**# 7, 8 & 9**

**SUB2011-00146, ZON2011-03251 & ZON2011-03252**

**ZONING AMENDMENT,  
PLANNED UNIT DEVELOPMENT &  
SUBDIVISION STAFF REPORT**

Star Imports Subdivision

# EXISTING SITE PLAN

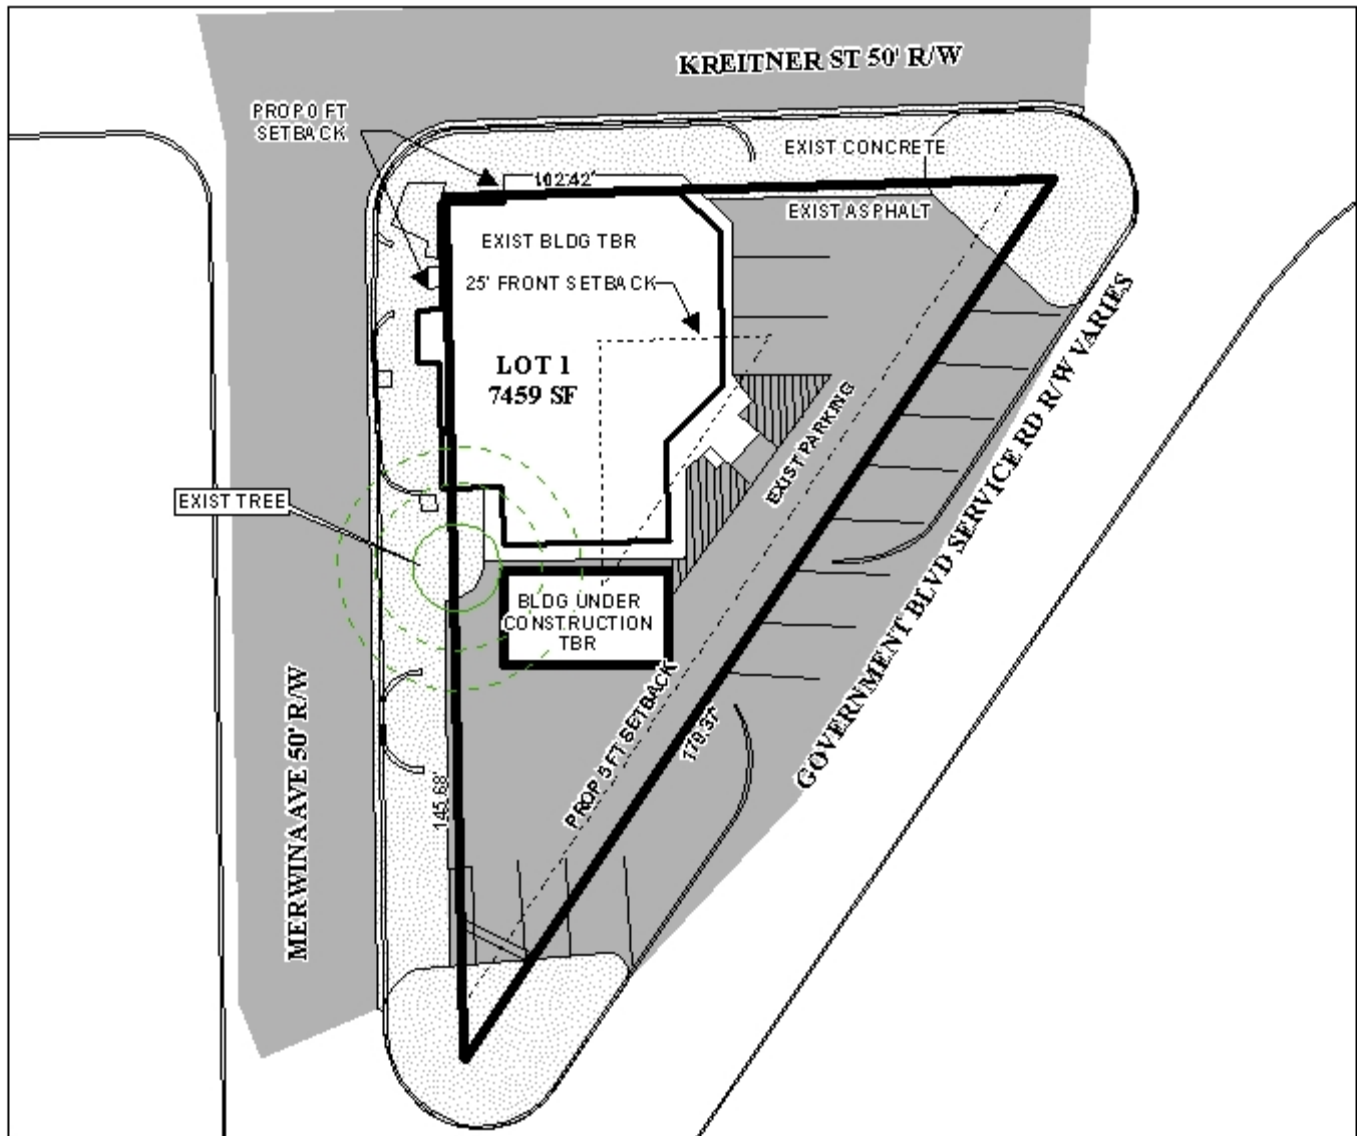
The site has essentially a continuous curb-cut along the Government Boulevard service road frontage, three (3) curb-cuts along the Merwina Avenue frontage, and one (1) curb-cut along the Kreitner Street frontage. The site should be limited to a maximum of one (1) curb-cut onto each street, with the size, design and location to be approved by Traffic Engineering and ALDOT (due to Government Street also being US Highway 90), with the curb-cuts to comply with AASHTO standards. Any unused or over-sized curb-cuts should be removed and landscaped.

The submitted site plan shows one existing oak tree, but otherwise does not depict any proposed landscape areas, nor any attempt to comply with the tree requirements of the Zoning Ordinance. The staff typically recommends the provision of frontage trees as a minimum for sites going through the PUD process, if limited new construction is proposed: such a recommendation would also apply to this site.

- 1) Dedication to provide 125 feet from centerline along Government Boulevard (US Highway 90);
- 2) Placement of a note on the plat stating that the site is limited to a maximum of one curb-cut to each street, with the size, design and location to be approved by Traffic Engineering and ALDOT, and to conform with AASHTO standards;

- 3) Removal of any extra or unused curb-cuts, and the restoration/landscaping of the right-of-way; and
- 4) Full compliance with all other applicable requirements of the Subdivision Regulations.

# PROPOSED SITE PLAN

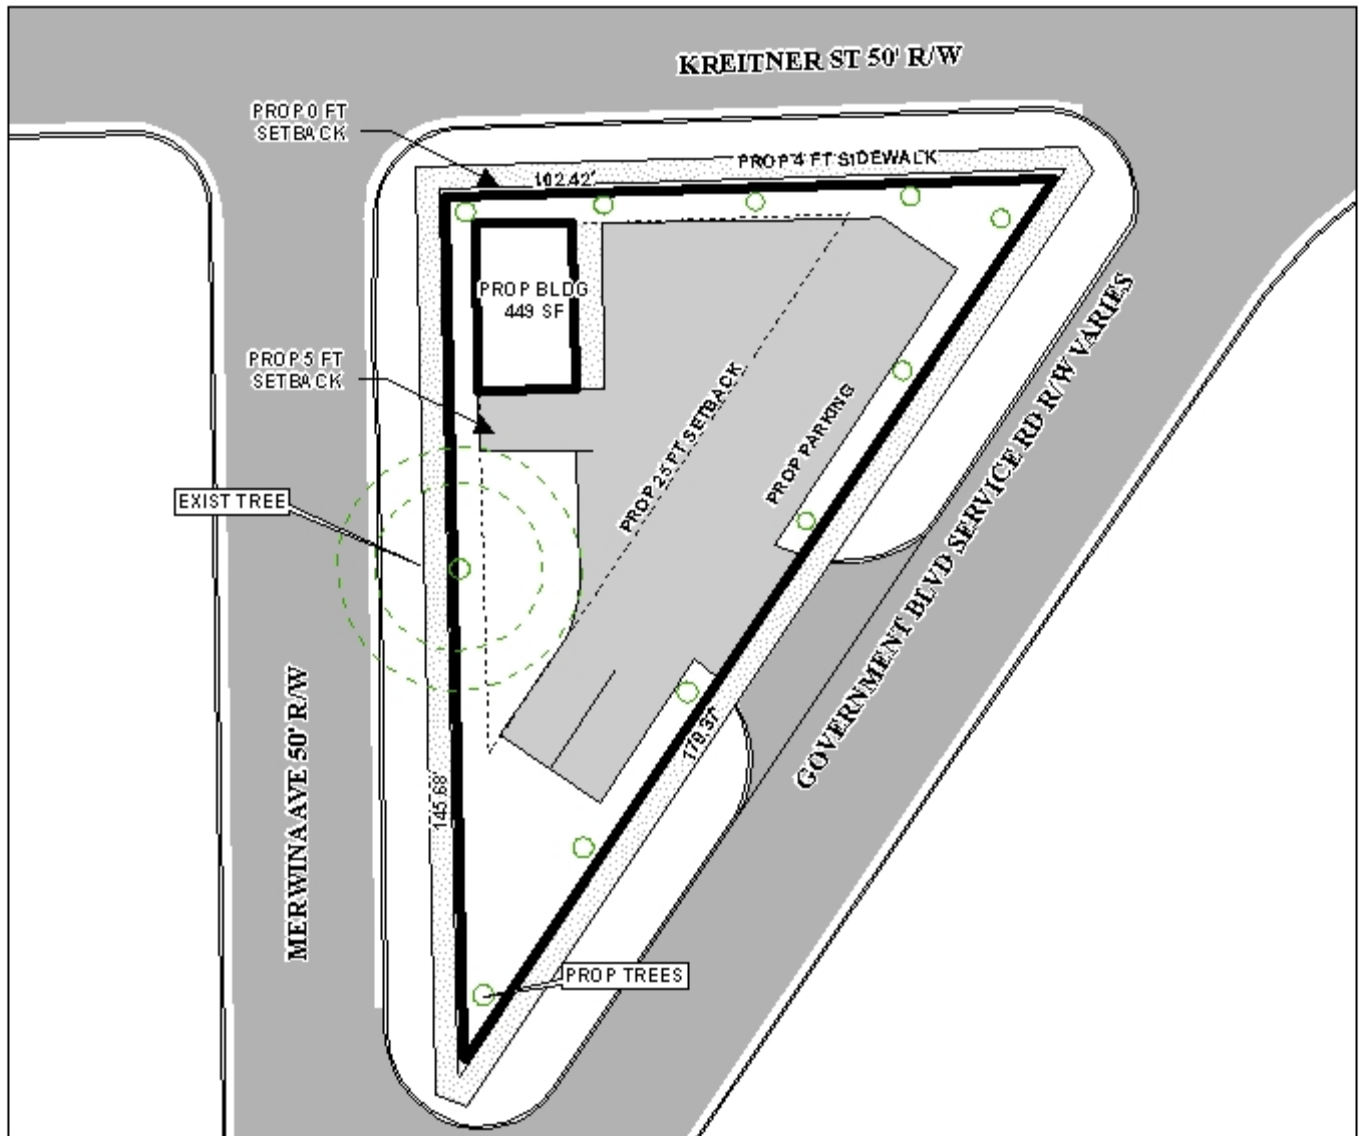
*The revised site plan illustrates only one driveway for the site from the Highway 90 service road; driveway number, size, location and design to be approved by Traffic Engineering and ALDOT and conform to AASHTO standards. Handicap accessible sidewalk ramps are required at all street corners. Since curbing is not illustrated, wheel stops are required for the three designated parking spaces. Based on the proposed use of the site, it may be appropriate to require additional wheel stops or similar obstruction along the perimeter of the paved area to prevent parking in landscape areas.*

*The applicant is now requesting five (5) foot setbacks along Merwina Avenue and Kreitner Street, and the standard 25-foot setback along the service road for Government Boulevard. The revised site plan does not reflect the right-of-way dedication along Government Boulevard recommended in the staff report.*

*With reduced setbacks, the applicant proposes to relocate the office trailer to the Northwest corner of the site: the existing vacant 1962-era restaurant will be demolished to allow for the proposed trailer placement. The placement of the office trailer to be 5-feet from the property lines along Merwina Avenue and Kreitner Street will be an improvement over the existing building, which is on the property line or partially in the right-of-way.*

*Regarding the proposed use of the site, the site plan depicts three (3) parking spaces, adequate for the size of the 449 square foot office trailer, however, Americans with Disabilities Act compliance may be required in terms of providing one handicap van-accessible parking space.*

*As for the proposed parking of vehicles for sale, staff estimates that the paved portion of the site not used for staff/customer parking and maneuvering, may only accommodate 10 vehicles, however, the applicant originally stated a desire to have twenty (20) to thirty (30) vehicles for sale on the site at any time: it appears that there is insufficient paved area on the site to allow the desired number of vehicles. Additionally, there does not appear to be any space on site to accommodate a truck that may load or off-load vehicles for sale, thus such a truck would have to park in the right-of-way of the adjacent streets, blocking traffic.*

*The revised site plan shows landscape areas and tree plantings. No information is provided regarding the amount in square feet of landscape area, thus staff cannot determine if adequate area is provided. As for trees, it appears that the site generally complies, however, two additional frontage trees may be required.*

- 1) Dedication of right-of-way for Government Boulevard (US Highway 90) will additionally reduce the size of the site, negating the site plan submitted;*
- 2) The use and design of the site, as proposed, will not provide adequate paved area for the proposed quantity of vehicles for sale; and*
- 3) Delivery or removal of vehicles for sale by truck will appear to require the use of adjacent rights-of-way, rather than being contained on-site.*

- 1) Dedication to provide 125 feet from centerline along Government Boulevard (US Highway 90);*
- 2) Placement of a note on the plat stating that the site is limited to one curb-cut, with the size, design and location to be approved by Traffic Engineering and ALDOT, and to conform with AASHTO standards;*
- 3) Removal of any extra or unused curb-cuts, and the restoration/landscaping of the right-of-way; and*
- 4) Full compliance with all other applicable requirements of the Subdivision Regulations.*
